25/01047/FULLN

**Re: 25/01047/FULLN At Western Avenue, Andover, Hampshire**

**Closure/stopping up and removal of southbound carriageway of Western Avenue gyratory and associated changes to the highway network, including West Street and Waterloo Court, to allow for the development of a park with areas of hard and soft landscaping, play areas, lighting, pavilion, river viewing platforms and an off-road cycleway**

- CJ009625-HEH-HGN-40012558-DR-CH-1014 to 1018 – Visibility Splays / Stopping Sight Distance Plans

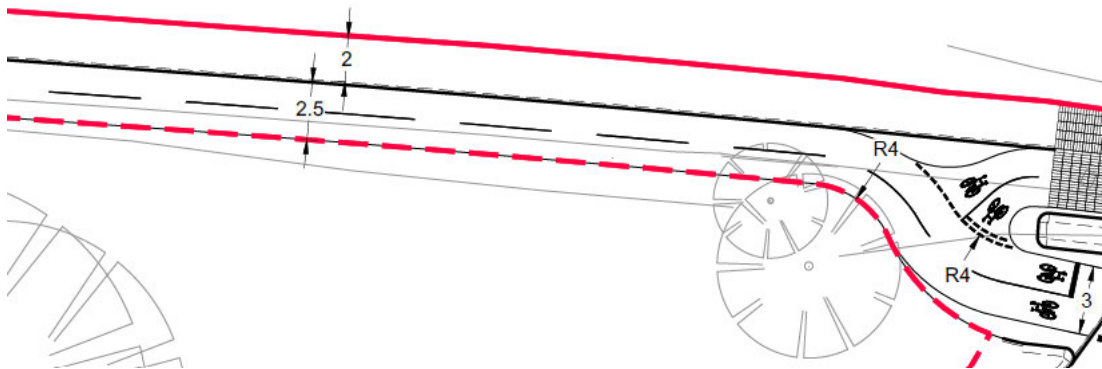
No splays are shown in vertical section or with reference to potential obstructions such as trees, street furniture, or level changes, although the RSA Stage 1 did not raise visibility concerns, formal technical approval will require all visibility envelopes be clearly dimensioned and justified.

Additionally, Identify and mitigate any visibility obstructions, including proposed landscaping, street furniture, or topographical changes and include visibility envelopes within cross-section or longitudinal profile drawings where applicable.

### Visibility Splays and SSD

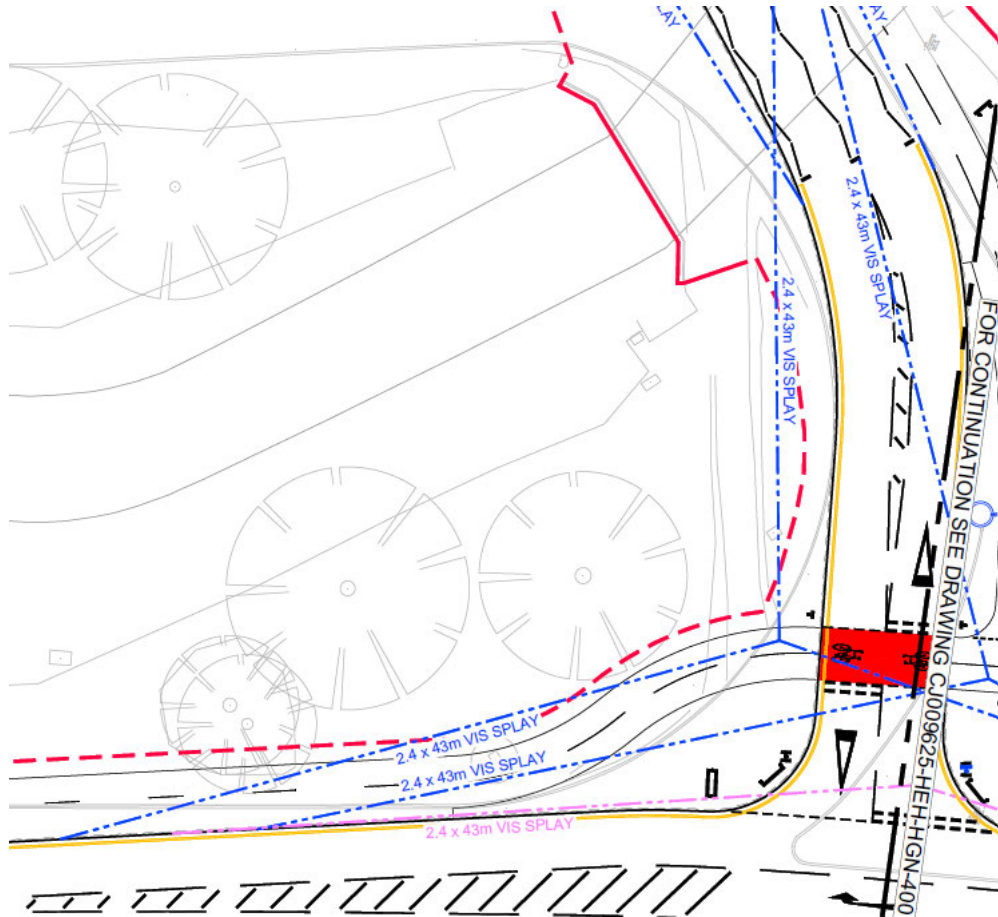
*Splays are noted as based on posted speed limits and not surveys given the vast changes in highway layout. The approach to this would seem sensible given the revised layout and how the highway operates this.*

*The area adjacent Waterloo Court requires visibility outside the highway. It is noted this area has highway boundary amendments. Any areas required for visibility should be dedicated to the highway authority. The red dashed line should be updated to suit.*

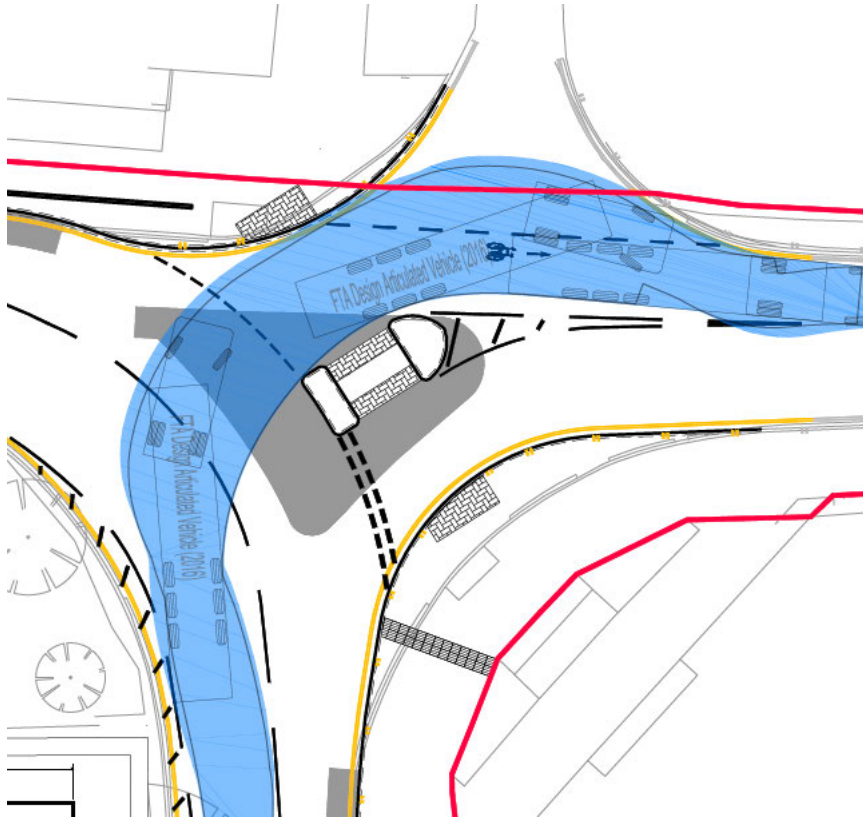
*The West Street/Chantry Street tracking has been improved from the pre-app stages with no overhang of pedestrian areas. The right in movement to Chantry Street does however require the vehicle to use the access of the area to the north requiring land outside the extent of the public highway.*

*Is this a regular movement expected?*
